**RE: Planning Compliance EN 2021/00015
Storage - Woodyard/contractors Depot
73 Greenbanks Road, Bridgewater**

**RE: STORAGE – WOODYARD/CONTRACTORS DEPOT
73 GREENBANKS ROAD, BRIDGEWATER**

Submission to Planning Authority Notice

Drawing
Proposed Location Plan

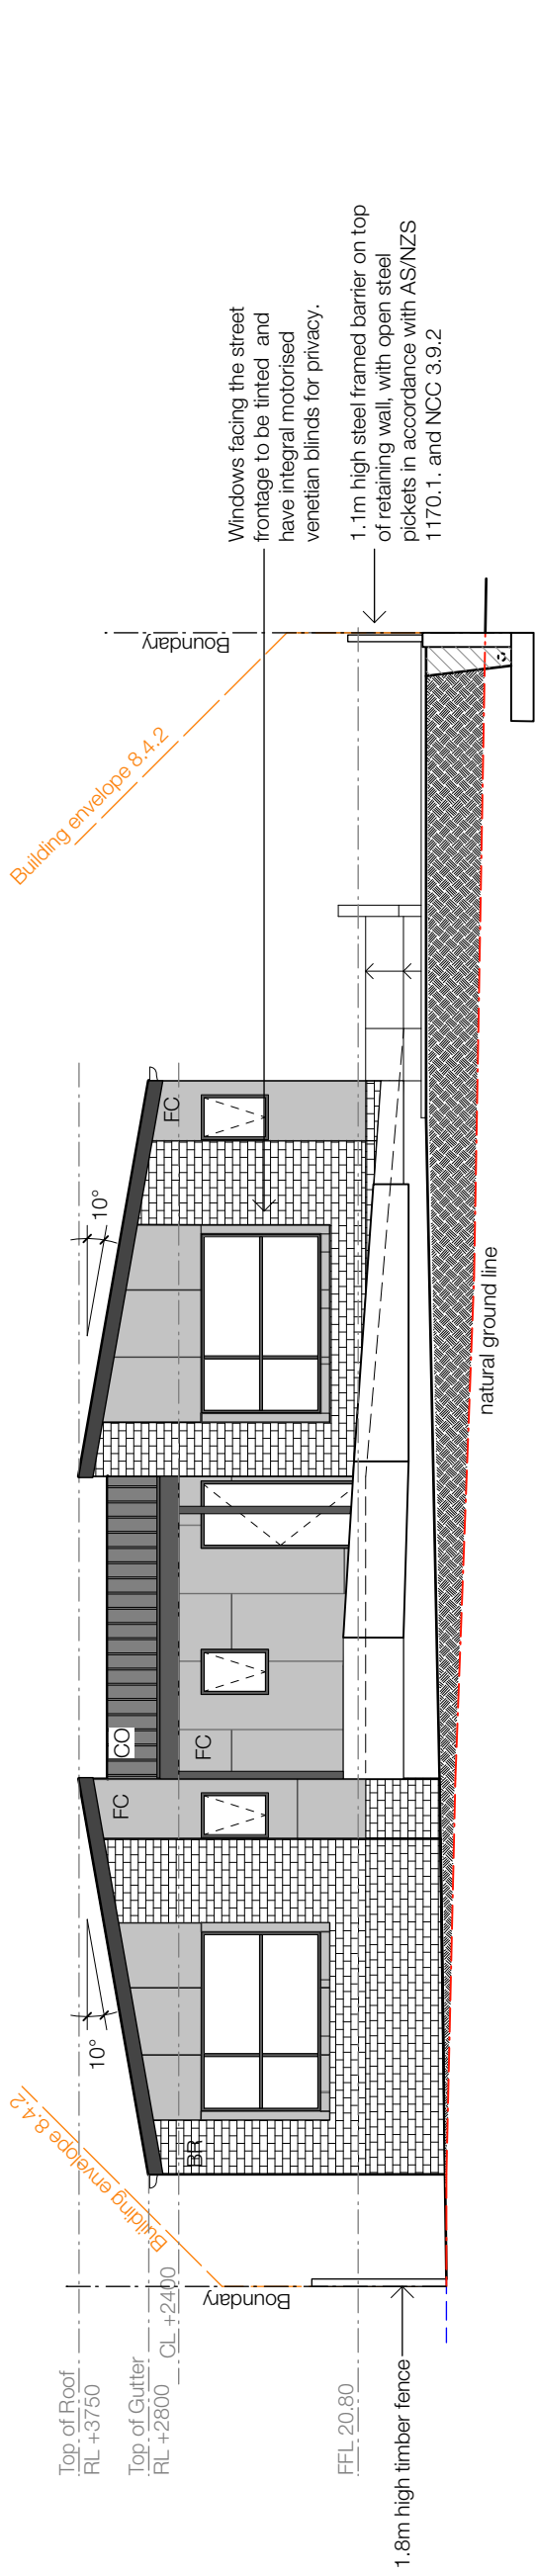
Rev	NO.	DATE	NOTE
C	22/4/22	Water, Sewer & Stormwater connections added as requested by Taswater's RFI	
B	18/3/22	Steel framed barriers noted & response to RFI dated 16.03.22	
A	9/3/22	Vehicle parking and sweep paths added; pedestrian paths amended in accordance with Planning RFI

- New DN20 Water Meters (3 off) on DN25 manifold to TasWater detail drawing TWS-W-0002 sheet 9 of 19 rev 5, with trafficable covers located within 500mm of the boundary and edge of driveway by Taswater at the Developer's cost.
- New New DN25 Water Connection by TasWater at the Developer's cost to TasWater Standard Drawings and approval.
- Location of existing 5000 Sewer main & 10000 Water main is based on site investigation & marking by Archer's Underground Services, as requested by TasWater RFI dated 18.03.22
- A Stormwater Design Report will be prepared by Saltmarsh & Escobar Consulting Engineers & will be submitted with Building Application drawings.

New DN25 Water connection by TasWater at the Developer's cost, to TasWater's Standard Drawings. DN25 Fire Sprinkler Water Supply to AS 2118.4 or AS 2118.5 in accordance with Taswaters guidelines.

1 South West Elevation
Scale: 1:100

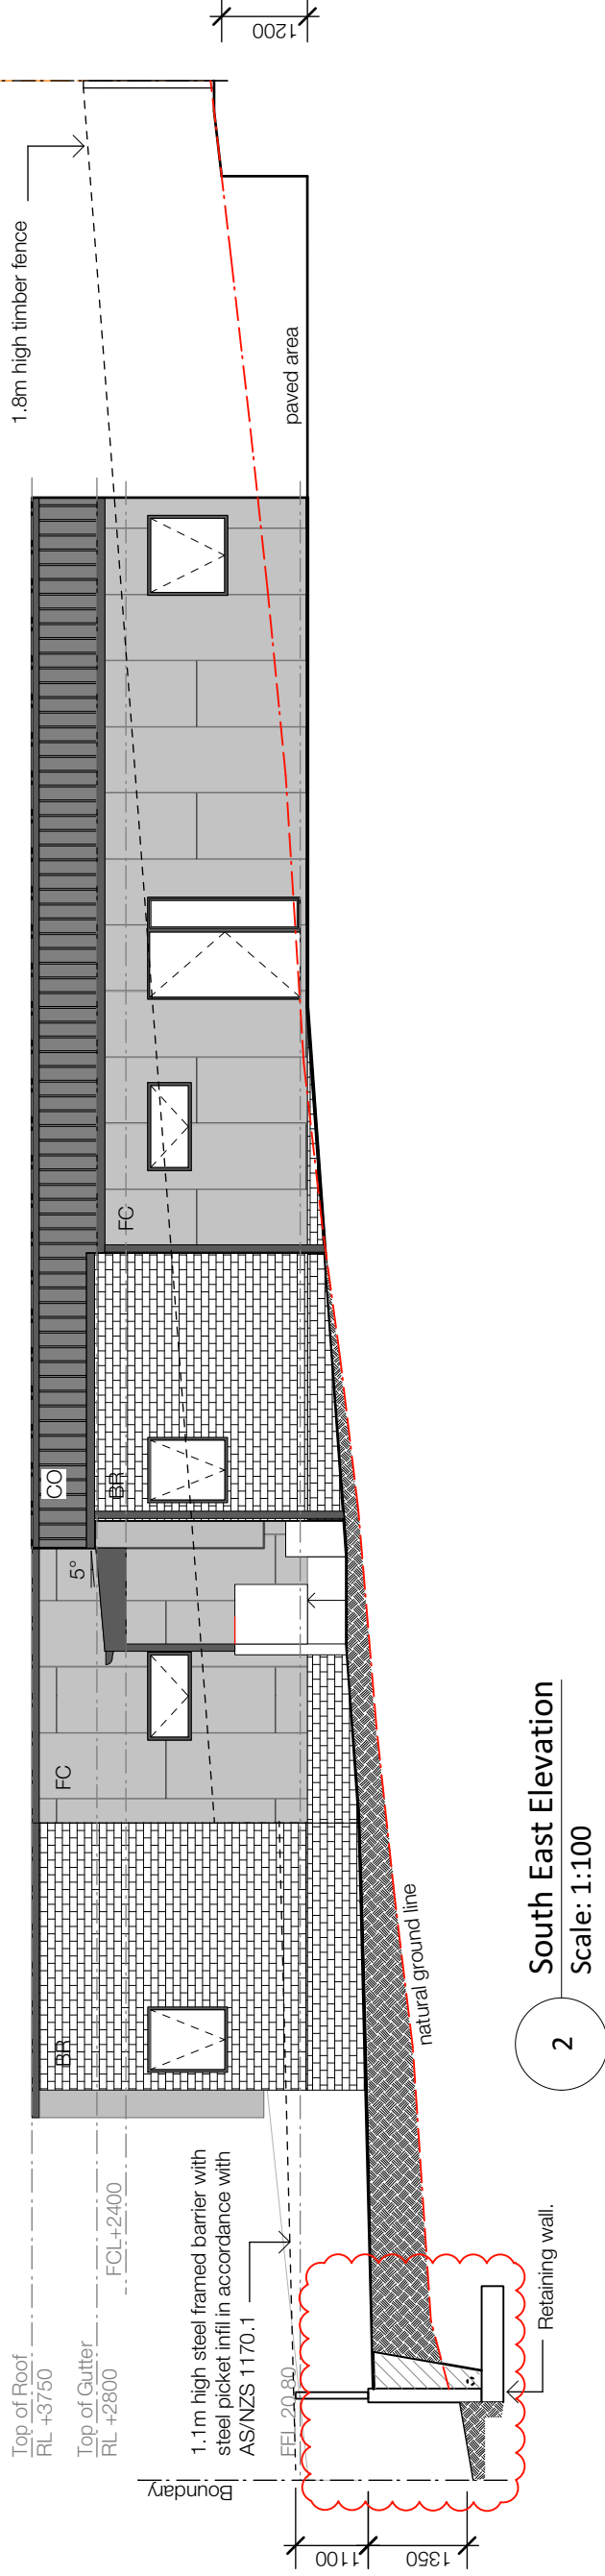
Rev	NO.	DATE	NOTE
C	22/4/22	Retaining wall offset from front boundary to comply with Taswater clearance from Water Main.	
B	18/3/22	Steel barriers noted & drainage to retaining wall shown, in response to RFI dated 16.03.22	
A	9/3/22	Floor level to units lowered; ground lines revised accordingly

1 Section along Existing Sewer Main
Scale: 1:100

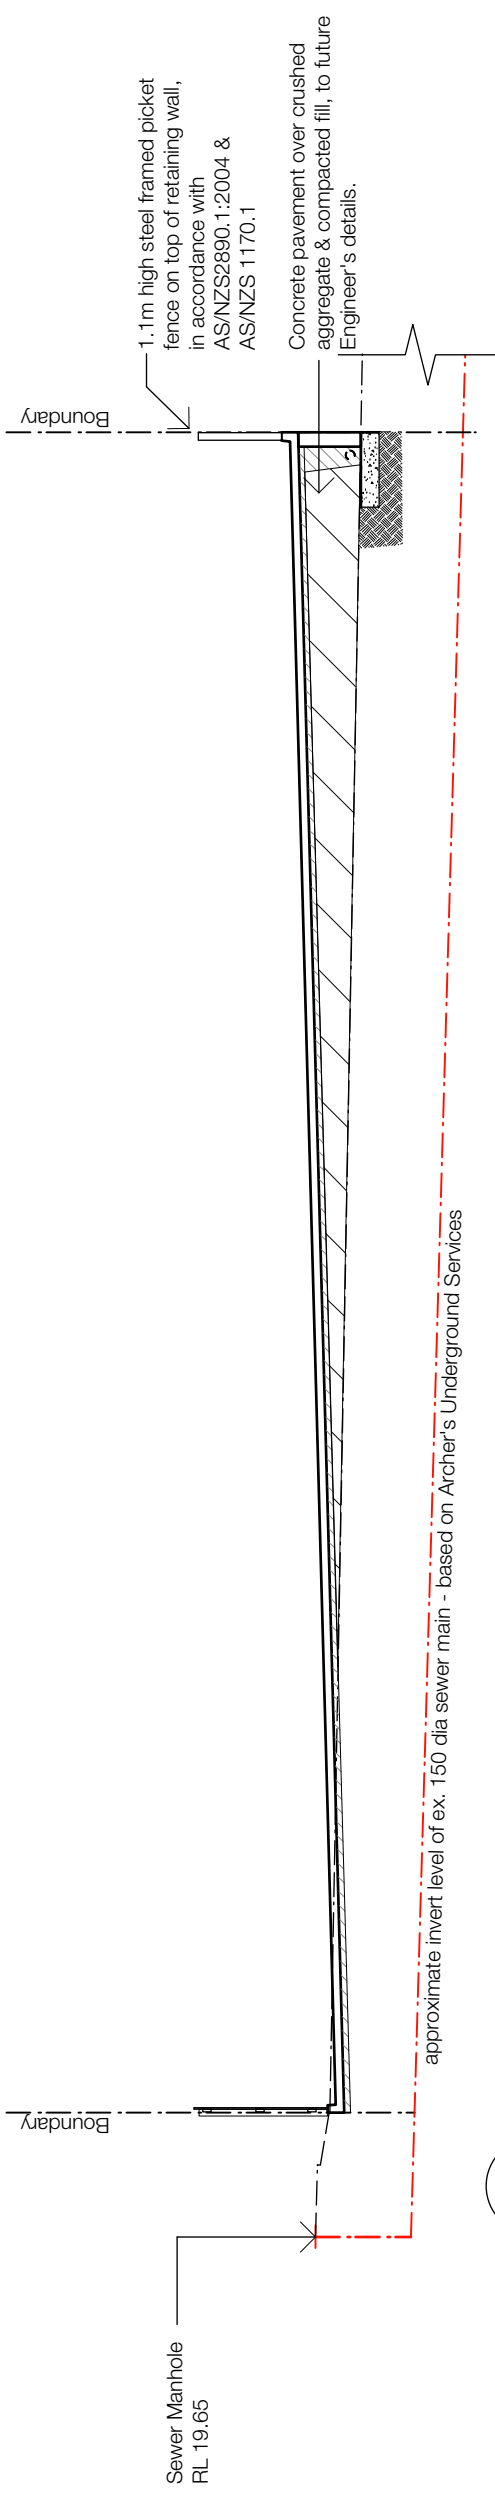
Rev	NO.	DATE	NOTE
A	22/4/22		Section added as requested by Taswater

- DEPTH OF EXISTING 1500 SEWER MAIN OBTAINED FROM ARCHER'S UNDERGROUND SERVICES SITE INVESTIGATION ON 19TH APRIL 2022.
